DEVELOPMENT APPLICATION ASSESSMENT REPORT

Application Number:	DA2025/0055
Responsible Officer:	Phil Lane
Land to be developed (Address):	Lot 4 DP 27133, 4 Taminga Street BAYVIEW NSW 2104
Proposed Development:	Alterations and additions to a dwelling house
Zoning:	C4 Environmental Living
Development Permissible:	Yes
Existing Use Rights:	No
Consent Authority:	Northern Beaches Council
Land and Environment Court Action:	No
Applicant:	Watershed Architects
Application Lodged:	29/01/2025
Integrated Development:	No
Designated Development:	No
State Reporting Category:	Residential - Alterations and additions
Notified:	10/02/2025 to 24/02/2025
Advertised:	Not Advertised
Submissions Received:	3
Clause 4.6 Variation:	Nil
Recommendation:	Approval
Estimated Cost of Works:	\$ 2,340,250.00

Image 1 - Demonstrating sill height provides adequate amenity for 4A Taminga St
Red dotted line indicates no direct views in private open of 4A Taminga St

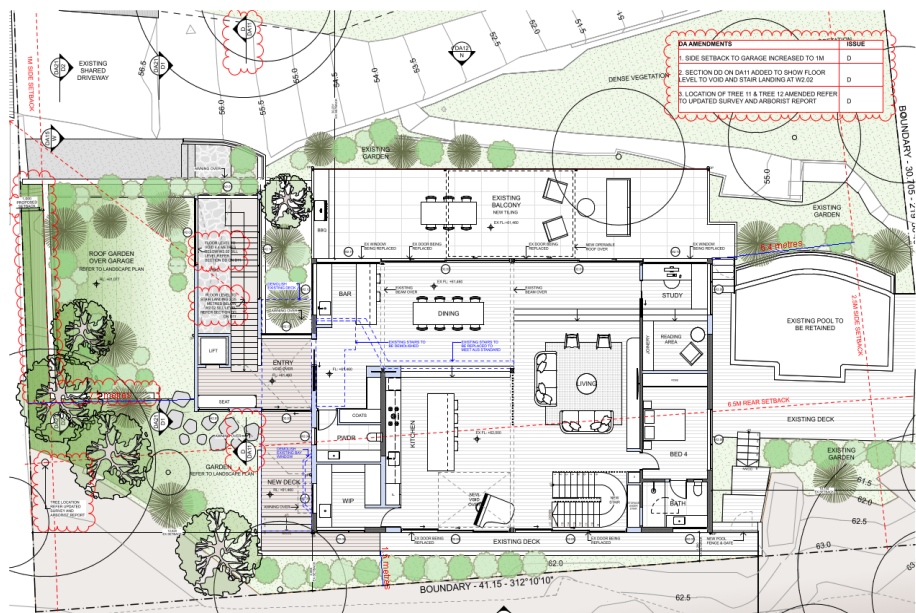
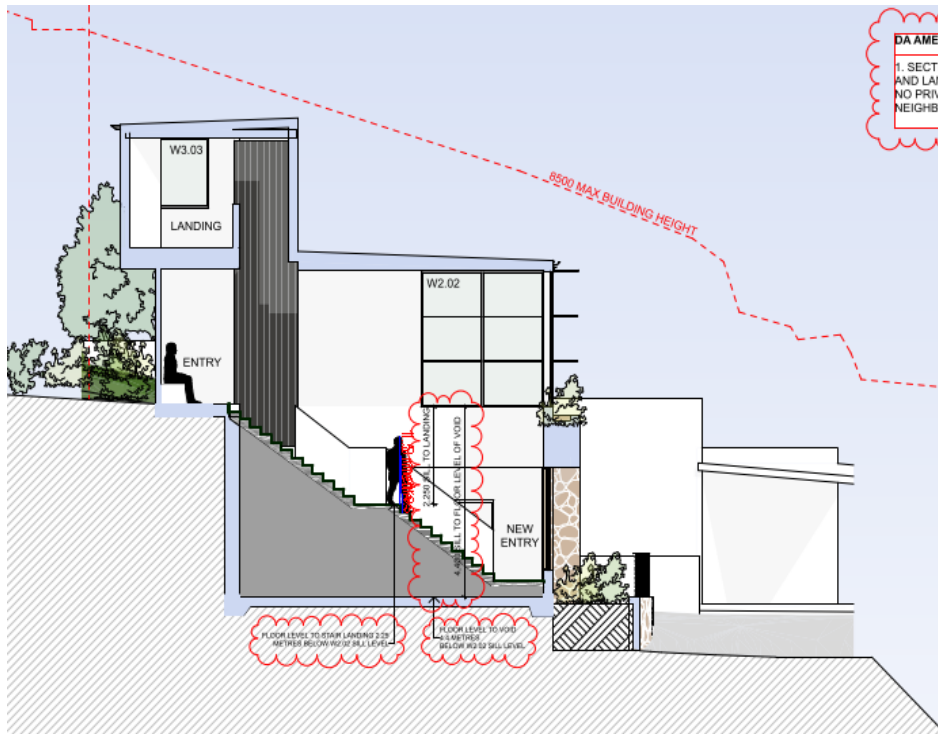
Issue: *Potential overlooking impacts from windows W2.02 (stair void) and W3.03 (lift landing).*

Comment: Amended plans (DA06 and Section DD on DA11) show that W2.02 does not result in significant privacy impacts due to sill height and internal stair orientation. However, W3.03 does not currently meet Clause C1.5 Visual Privacy. A condition of consent will require W3.03 to be fitted with either obscured/frosted glazing or fixed external louvres angled to prevent direct views to the southwest.

Figure 5: Area above 8.5m height plane highlighted in purple

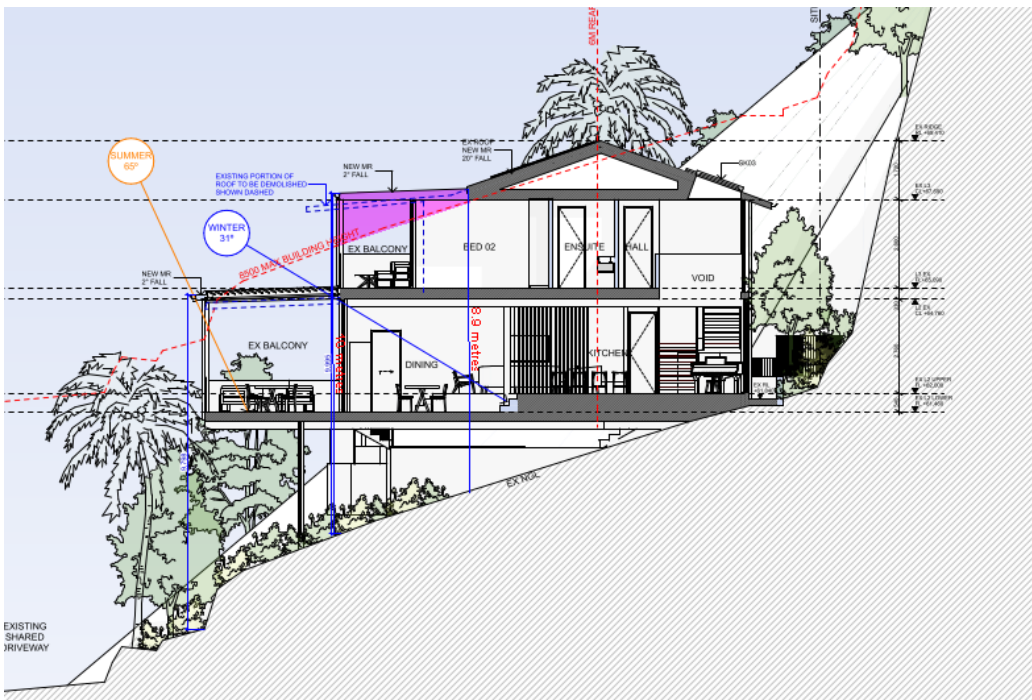
The areas of the dwelling house that protrude above the 8.5m height plane are confined to minor portions of the pergola over the top floor balcony and the roof within these portions of the dwelling. The breaches occur for a horizontal length of 3.9m for a vertical length of 1.5m. Figure 5 below depicts the areas that protrude above the 8.5m height plane. These areas above the 8.5m height limit are considered minor given the low percentage (7.2%) these areas demonstrate overall versus the high percentage (82.8%) of the building demonstrates compliance with the 8.5m height control. It is important to note and recognise that where the roof breaches the height limit, it is in a similar position and extent of breach of the existing roof, which is being replaced.

Level 3 Floor Plan - W3.03 with vertical projection on the northern edge

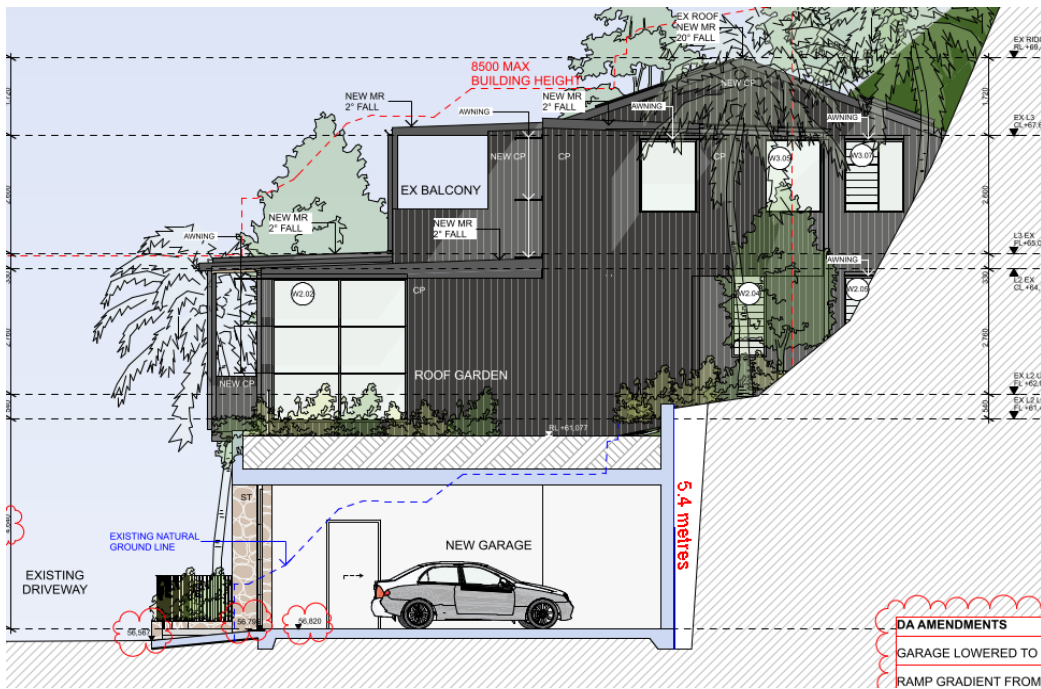
Section BB - Window 3.03 with awning (located on top floor)

- Window W3.03, located adjacent to the landing on Level 3, must be fitted with obscured/frosted glazing and/or external louvres angled to the southwest. The louvres must have a maximum spacing of 0.2m and a minimum blade length of 0.4m to ensure compliance with visual privacy controls.
- A heavy-duty, pedestrian-safe box grate drain must be installed across the full width of the existing driveway. The drain is to have a minimum width of 0.2m and a minimum depth of 0.2m, and must connect to the proposed drainage system detailed in the plans prepared by Northern Beaches Consulting Engineers.
- The stormwater drainage plans prepared by Northern Beaches Consulting Engineers must be updated where necessary to reflect the approved amended architectural plans prepared by Watershed Architects (Revision D).
